Flat 2, 35 Highcroft Villas

BH2026/01425

Brighton & Hove
City Council

- Proposed alterations to the roof, including an increase in ridge height, a dormer to the rear roof elevation, and a second-floor flat roof extension over the existing outrigger, together with the provision of off-street car parking spaces and a new vehicular crossover.

Proposed Elevations

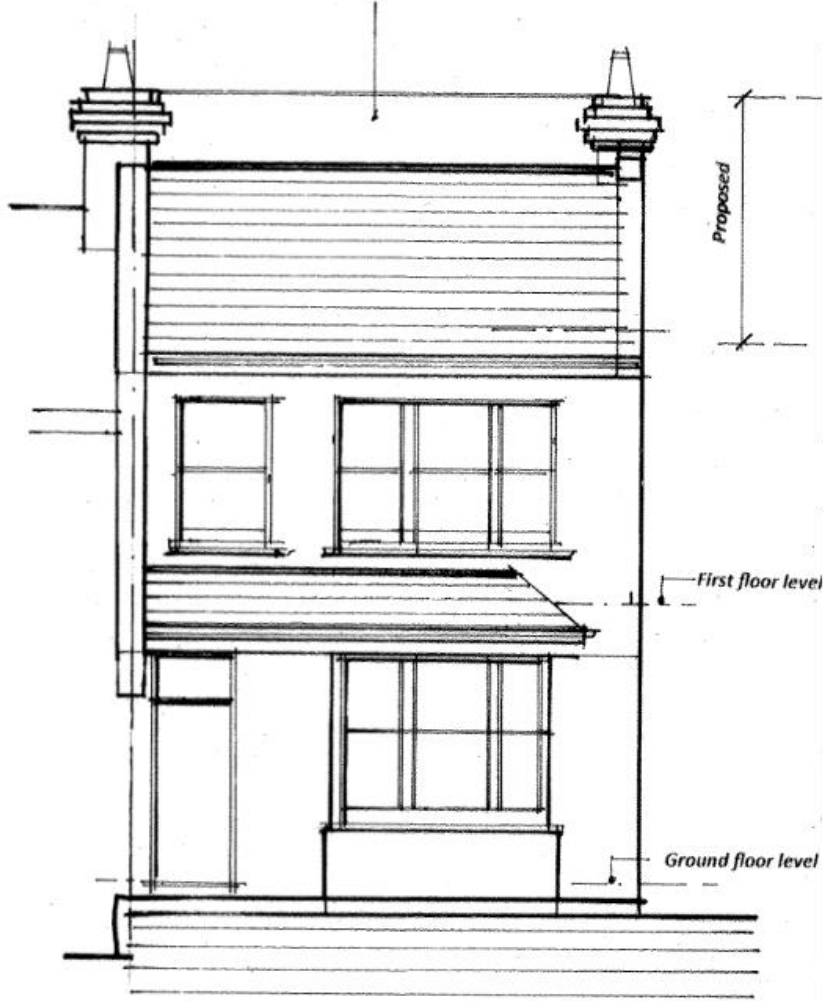
New area of pitched roof would not be visible from ground level at the front of the building.

Proposed side elevation(West)

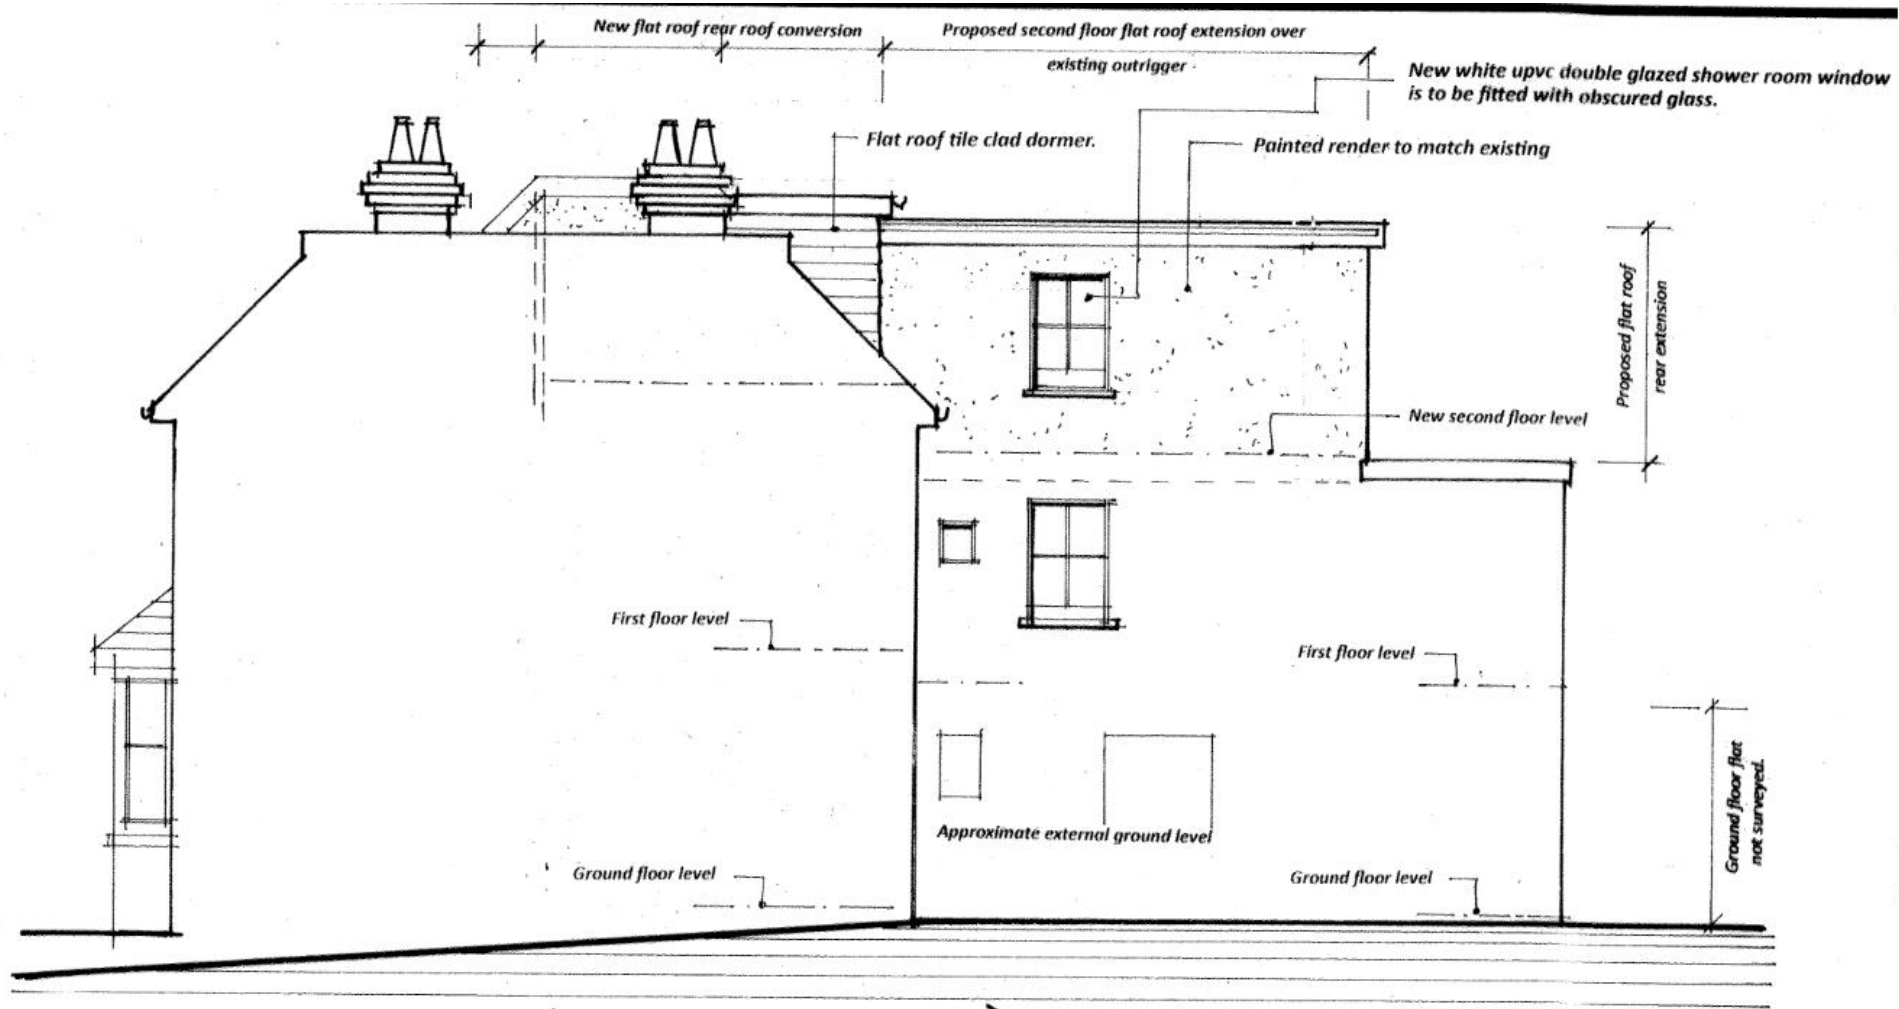
- ▶ Obscure glazing of the west-facing shower room window would be secured by condition to protect neighbouring privacy.
- ▶ Rear-facing windows would introduce higher-level views, but these are not considered to materially alter the existing pattern of mutual overlooking.

- ▶ The side windows on the western elevation of the development hereby permitted shall be obscure glazed, and thereafter permanently retained as such.
